Re: Allouez, Wisconsin  
US Cellular Equipment Modernization Plan Review  
Site No. MC 781314  
McM. No. A0012-09-21-00343.00

This letter addresses US Cellular's request for the modifications of antennae and ancillary equipment on the Village's standpipe. McMahon Associates, Inc. reviewed the construction plans dated 4/5/21, and the structural analysis reports dated 3/26/21 and 3/29/21. Below are our review comments:

**B** PROPOSED ANTENNA LAYOUT

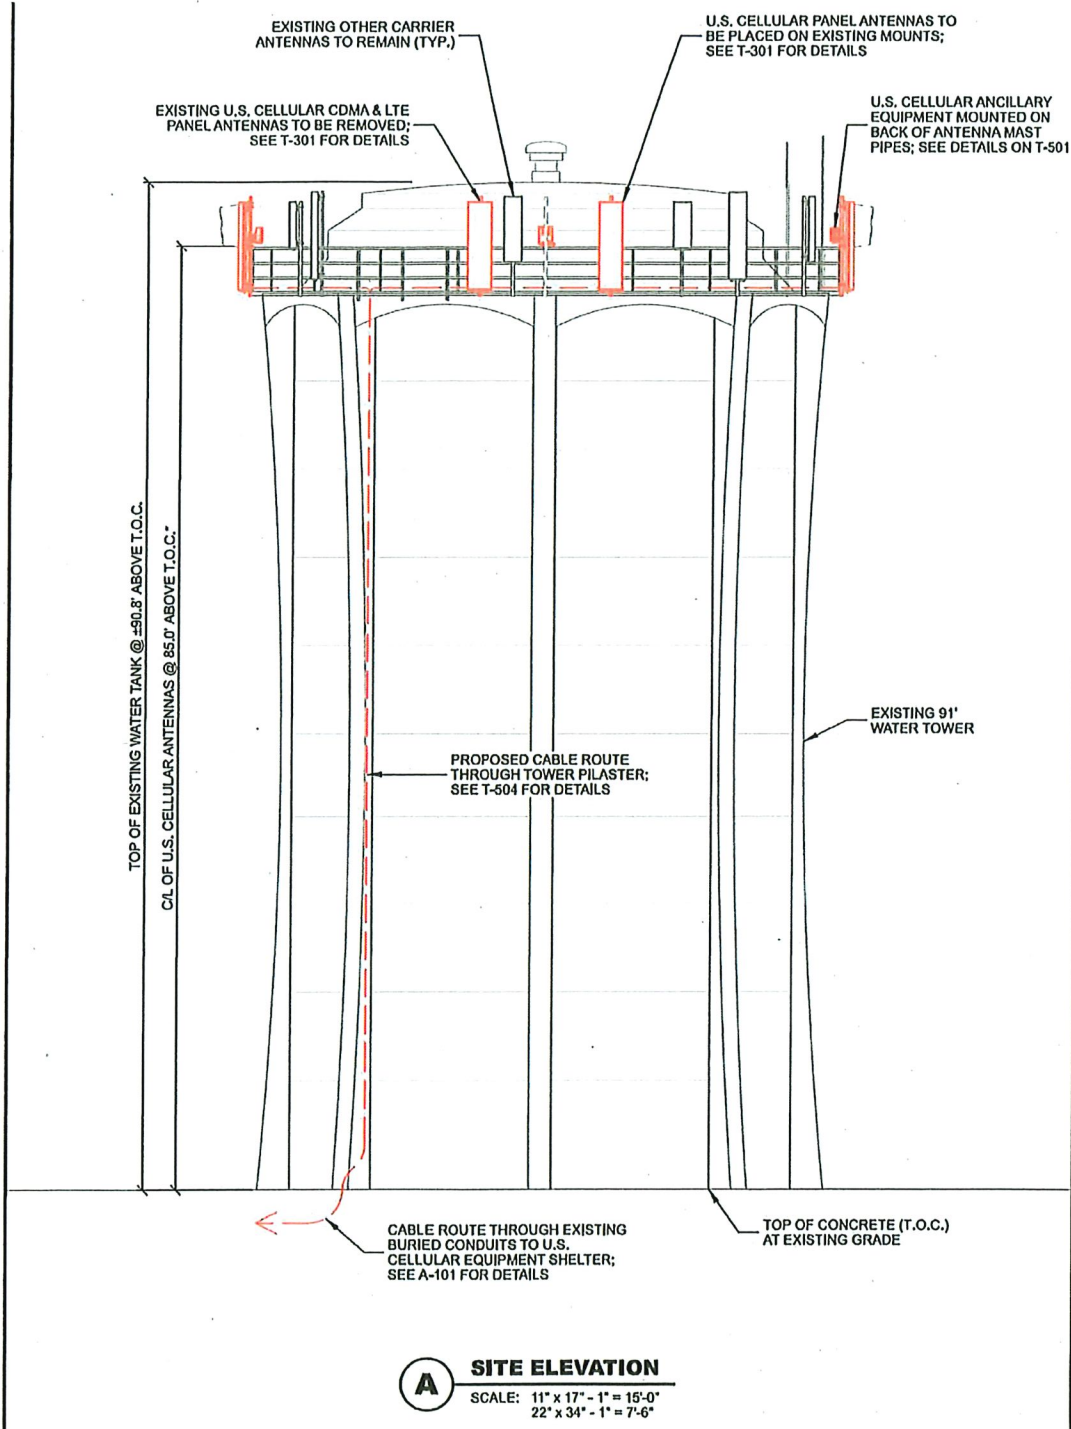
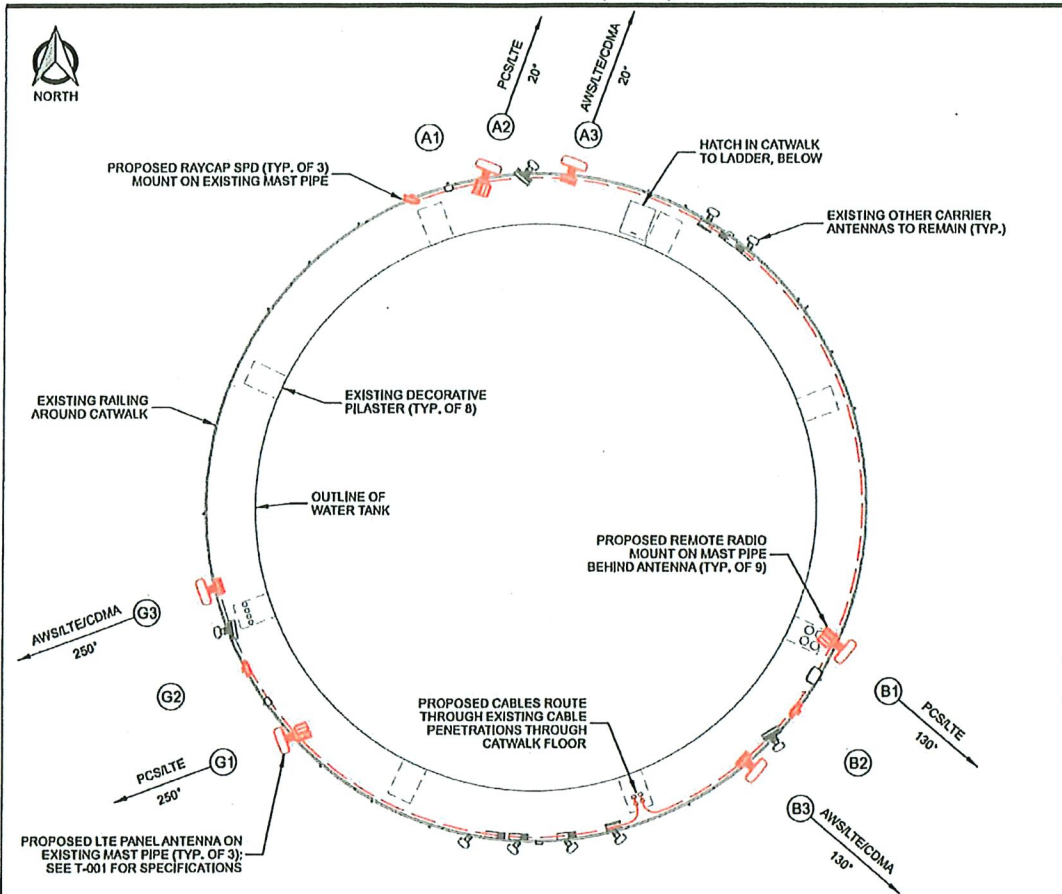
1. Touch-up paint antenna masts where paint is missing due to mounting changes and antenna removals.
